Addendum No.3
to
CONSTRUCTION DOCUMENTS
for

NCISD New District Administration Building
21330 Valley Ranch Parkway
New Caney, TX. 77357
June 2, 2025

Below is a summary of the sheet and specification revisions for Addendum #3.

A-145

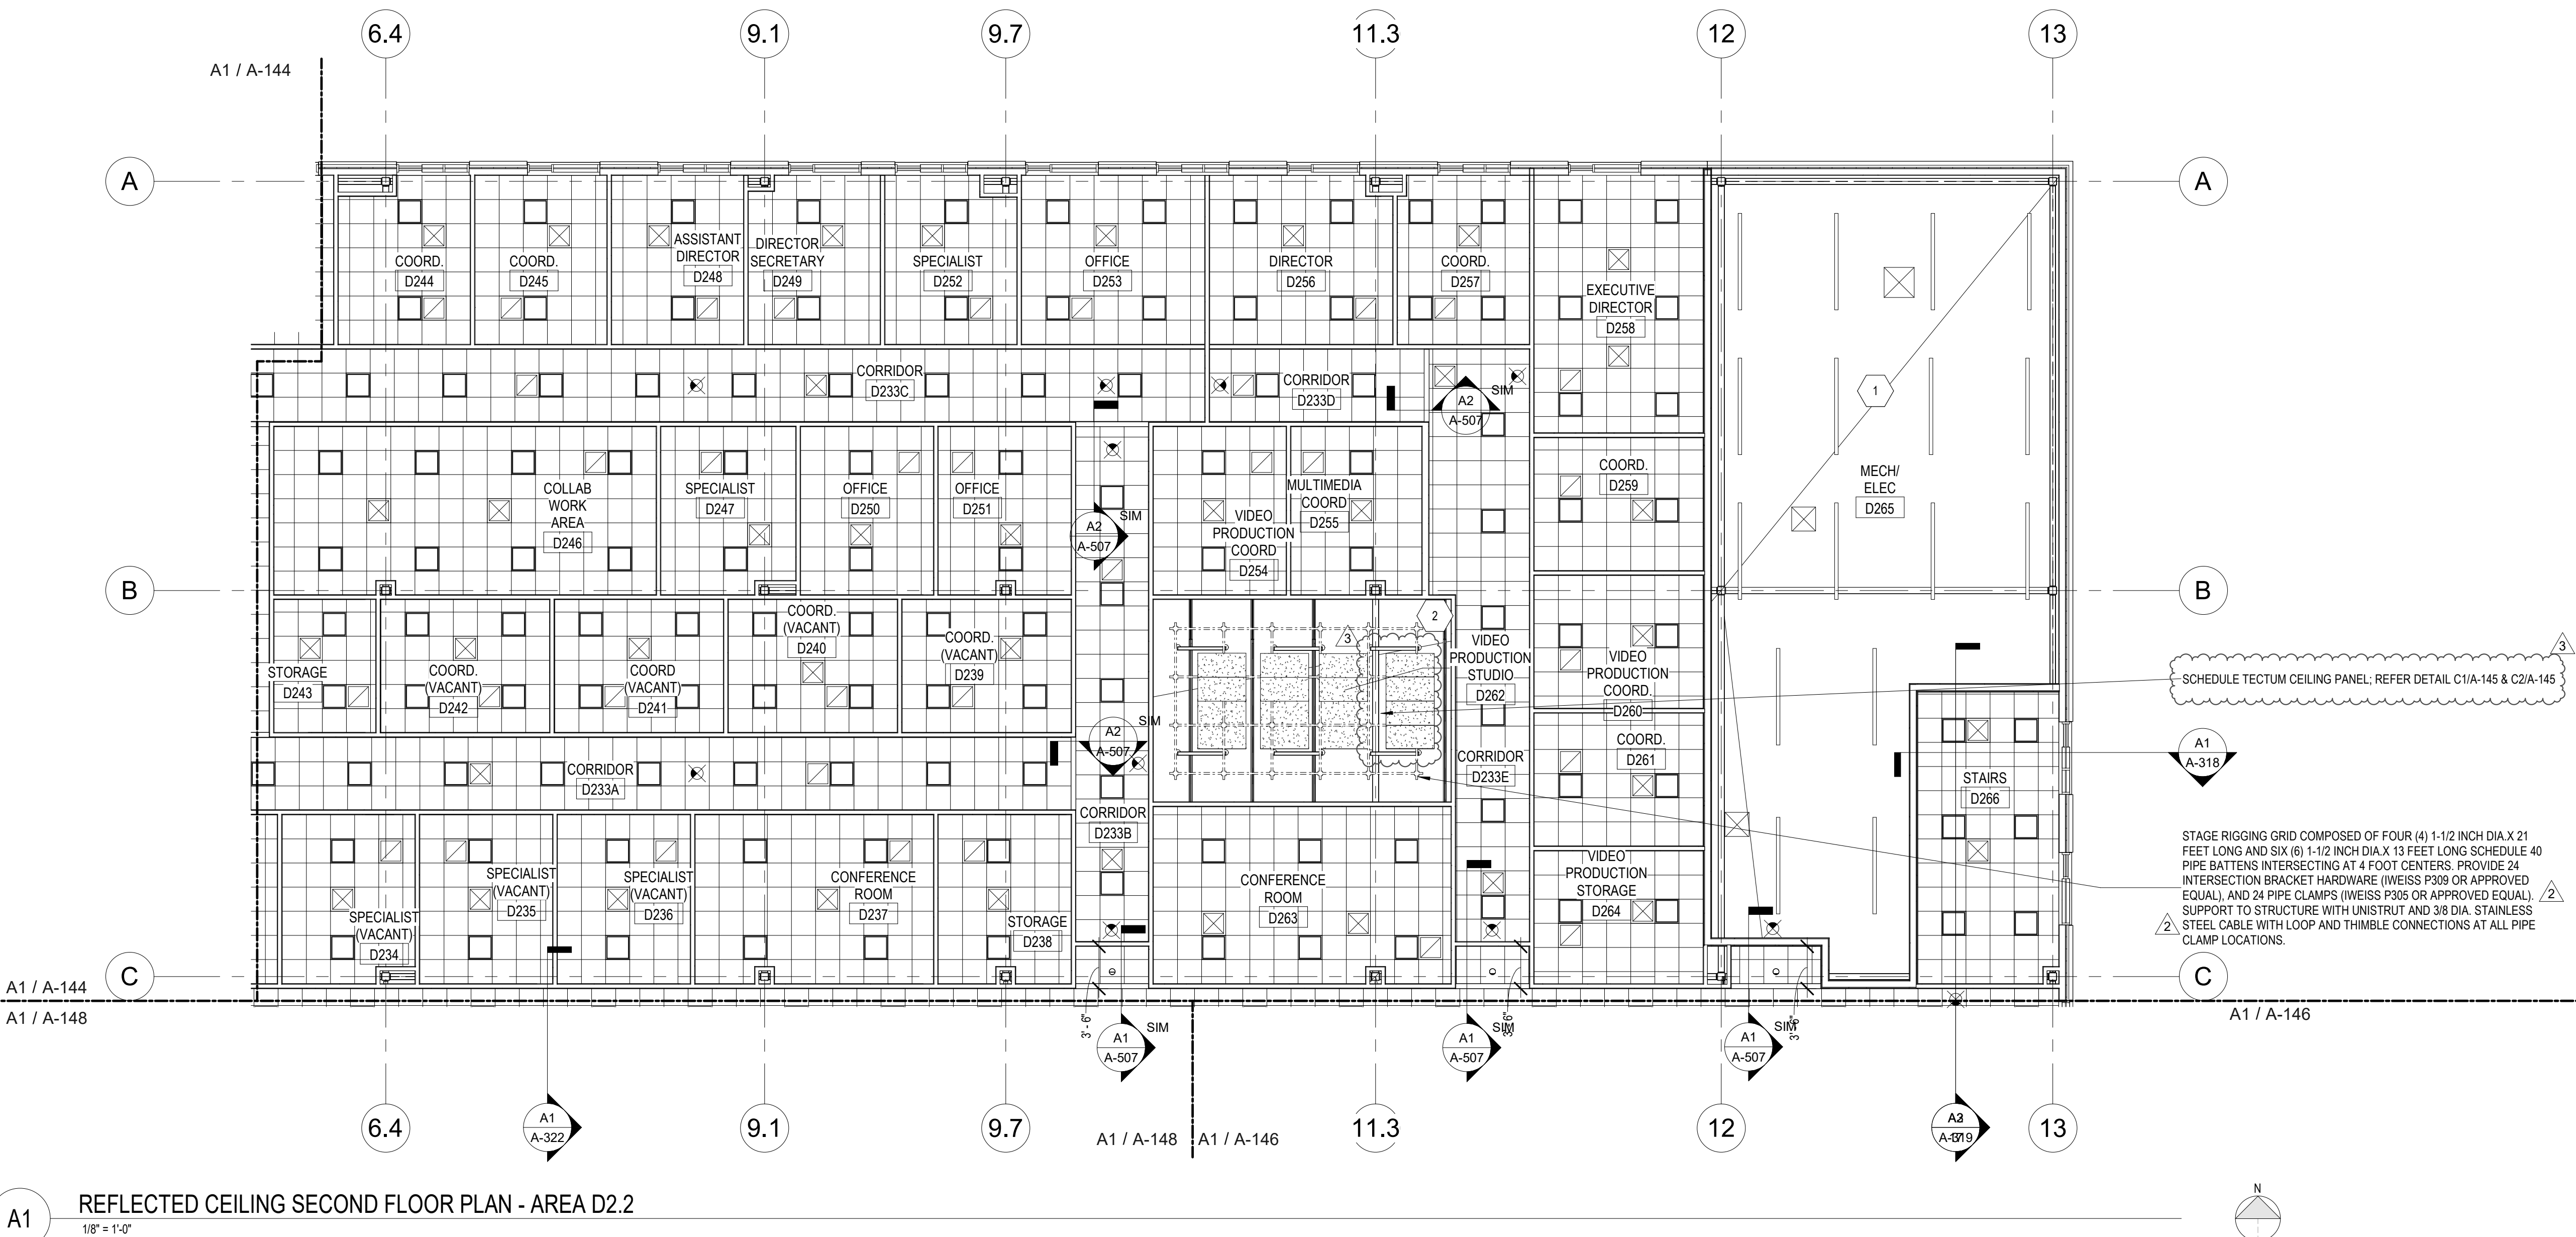
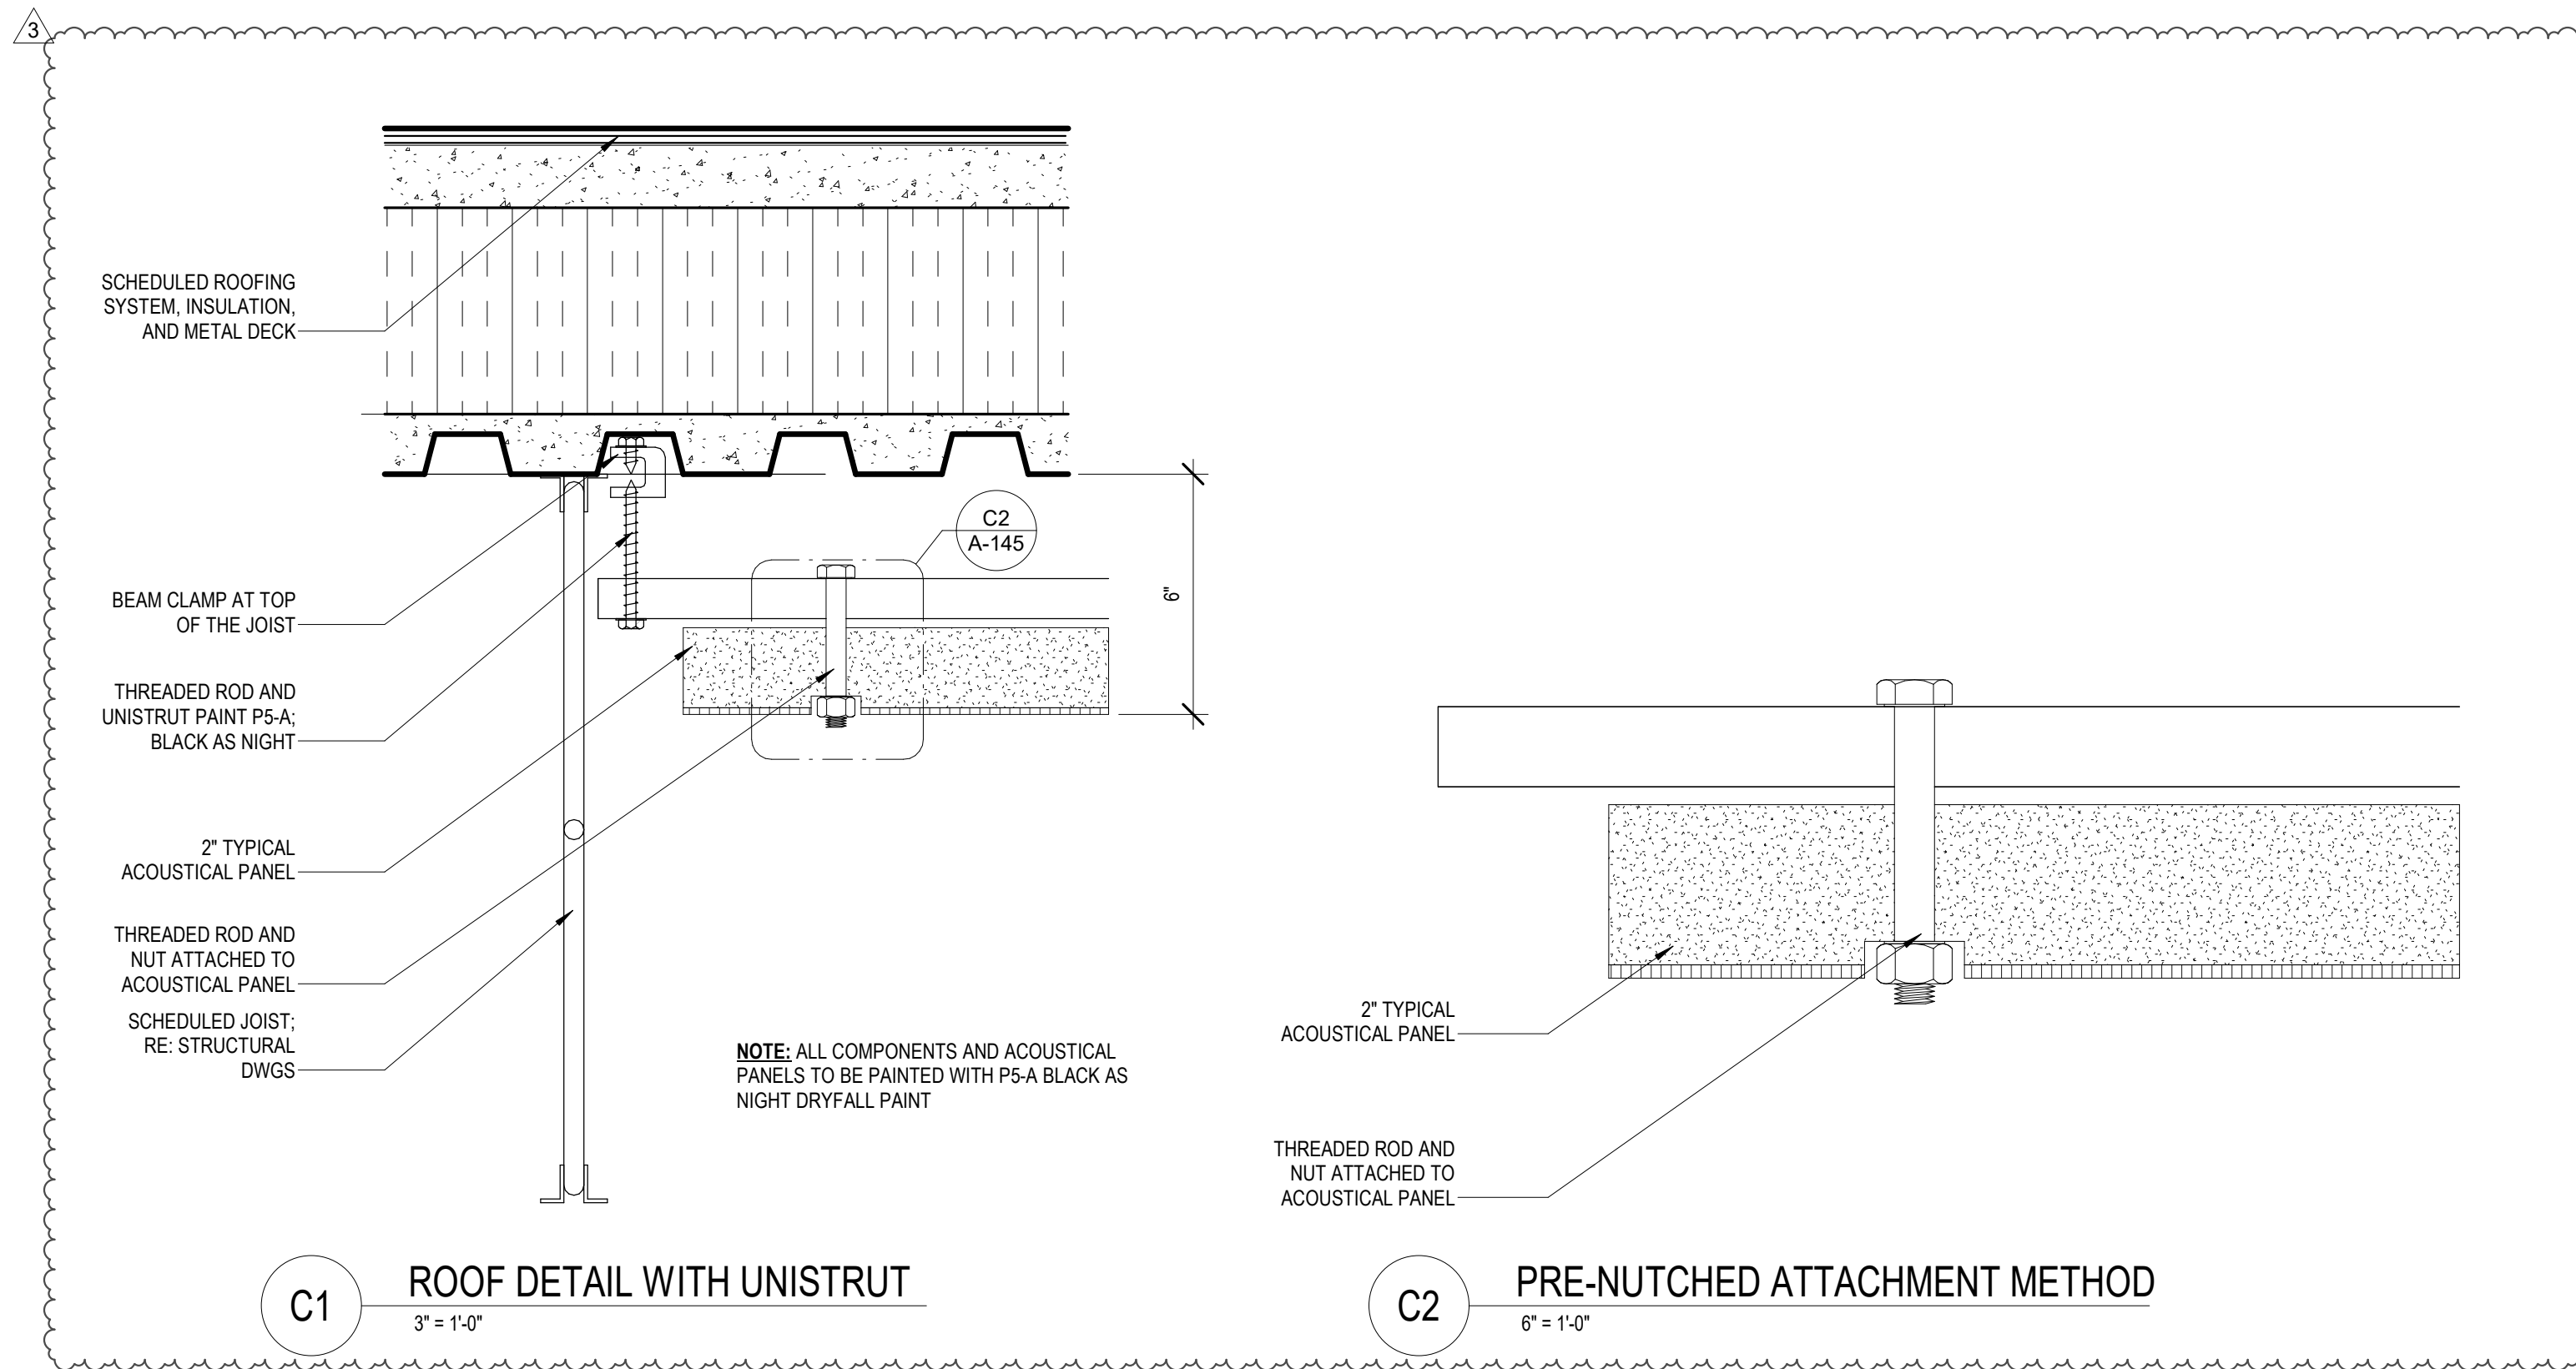
- 13. Sheet A-145 – REFLECTED CEILING SECOND FLOOR PLAN – AREA D2.2
 - a. Added detail C1/A-145 and C2/A-145 to illustrate acoustic panel attachment with Unistrut.

- b. Added scheduled tectum ceiling panel graphically and note on RCP A1/A-145

ISSUED FOR: 100% CDs	
PERMIT	05/08/2025
BID	05/08/2025
CONSTRUCTION	05/08/2025
RECORD	05/08/2025
PROJECT MANAGER	DESIGNER
CP	KA
JOB NO. 2023159.00	
C3.00

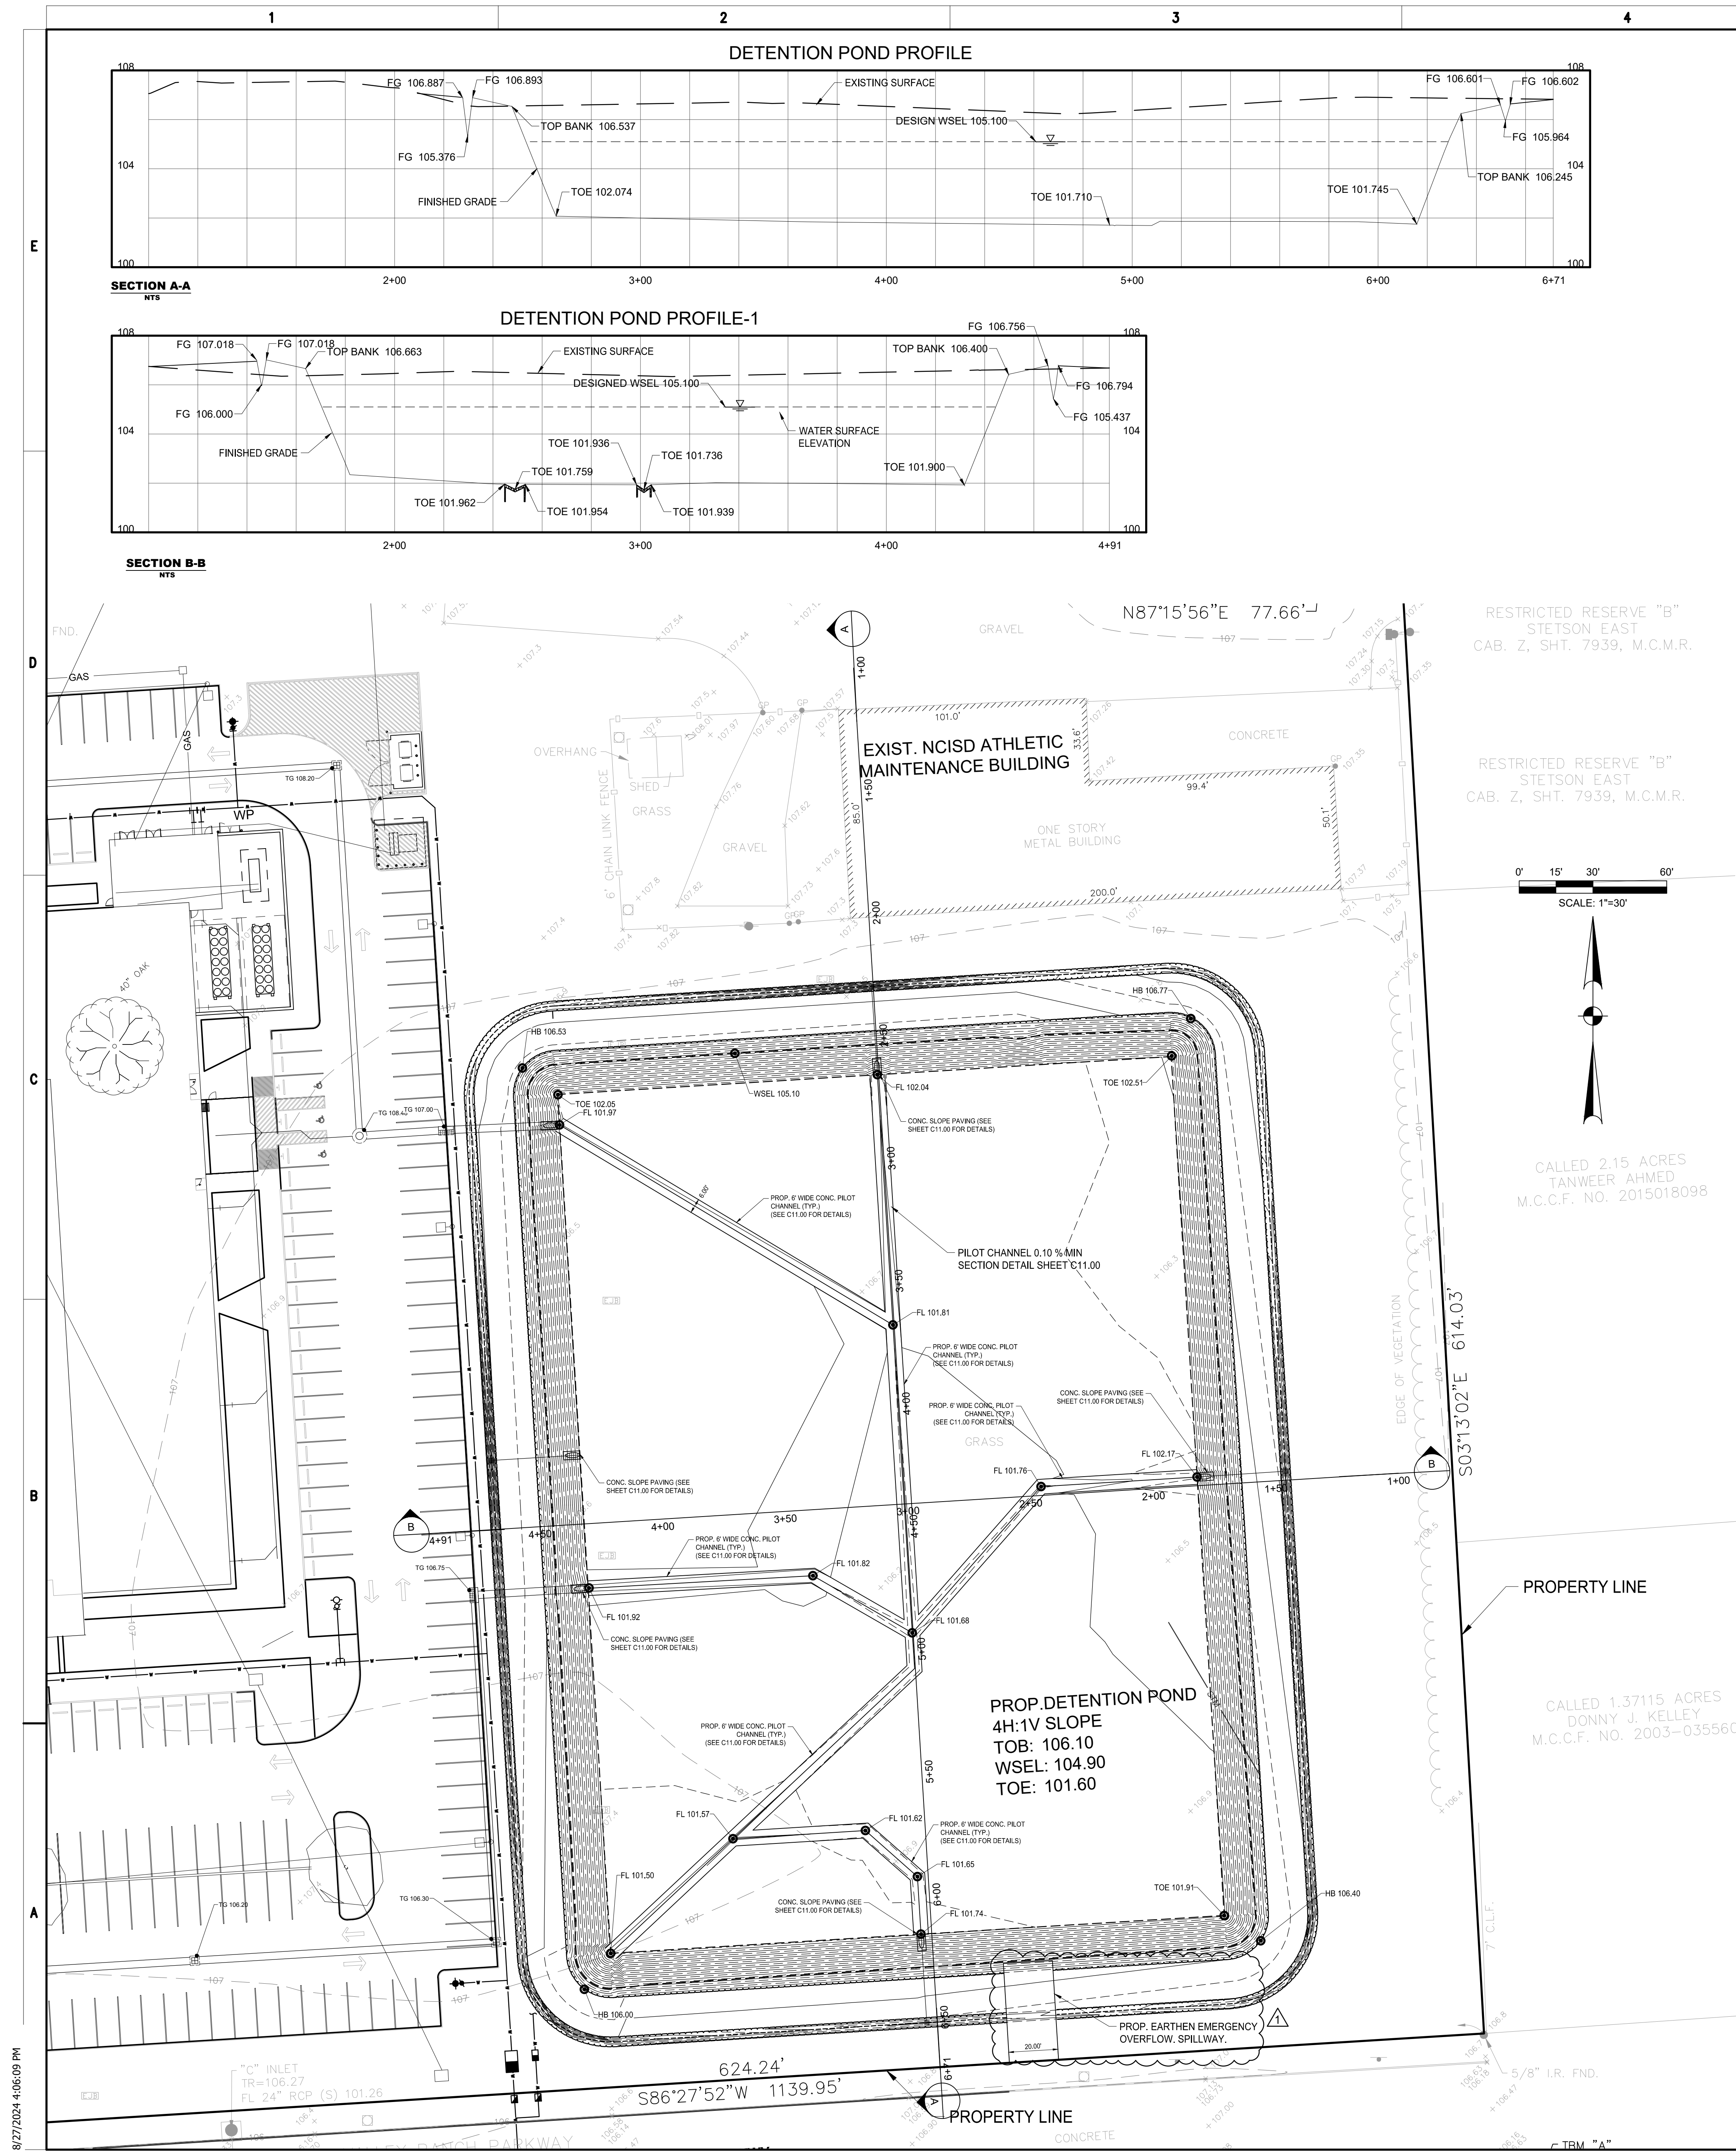
C3.00 PAVING PLAN

- Revised emergency overflow spillway material from concrete to earthen.
